# Proposal for Modification of PD Cable Supports

FD1 Technical Board Meeting

December 5, 2023

New grommet cover detail

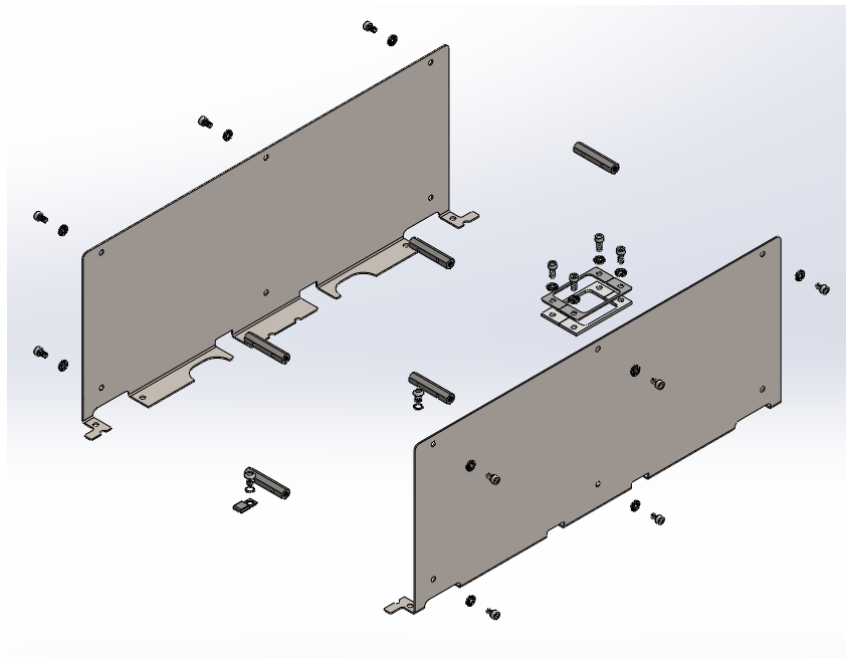
- A Teflon grommet is used to prevent PD cables rubbing against the APA frame edge where the cables pass through the APA foot tube.
- Experience at Daresbury and Chicago show that the grommet is deformed during installation.

# Proposed Stainless Steel Grommet Cover (i)

Closeup of grommet cover assembly

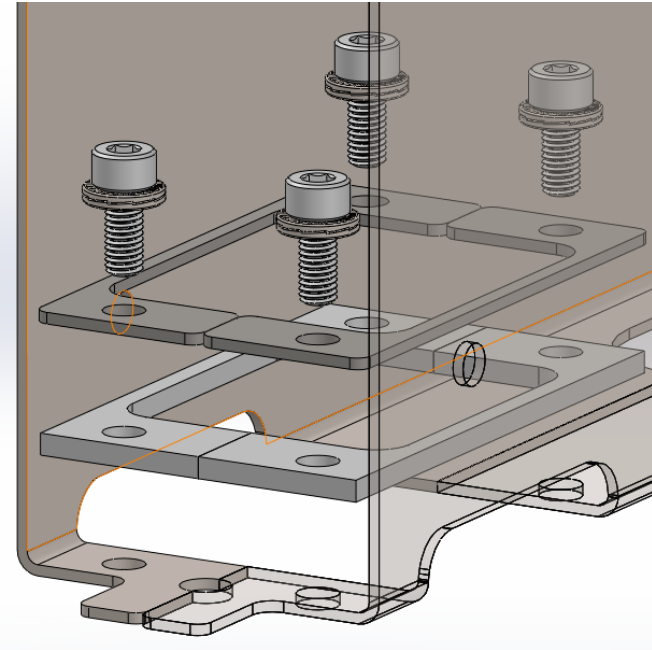
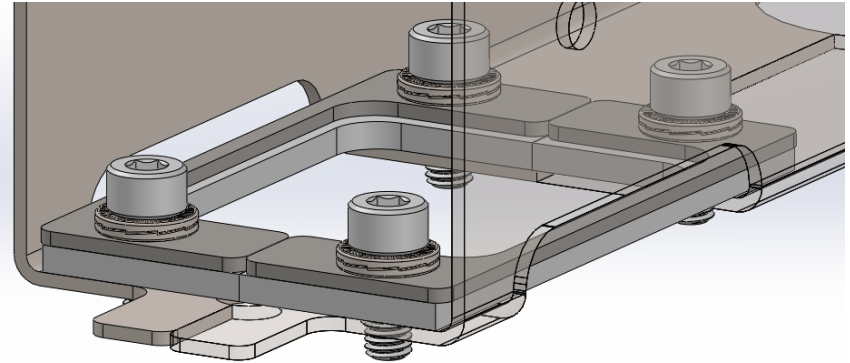
Note existing screws extend 4.8mm (nominal) into 3mm thick foot tube wall

# Grommet Cover Installed in APA (Chicago)

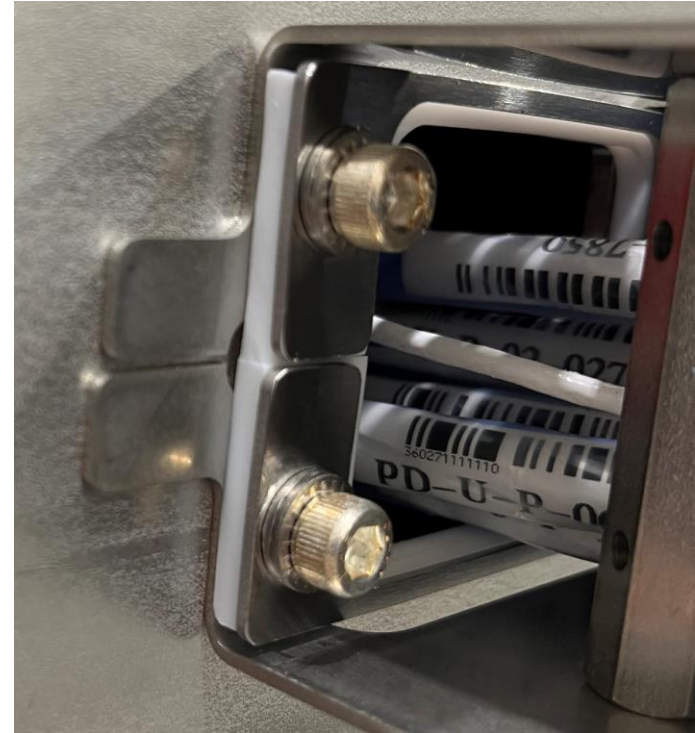
- Sample pieces fabricated and tested in Chicago APA 1.
- Did not have a negative impact on cable motion.
- Simplified installation of cable containment bracket.
- Very low cost (~\$50/APA, \$3,750 total).
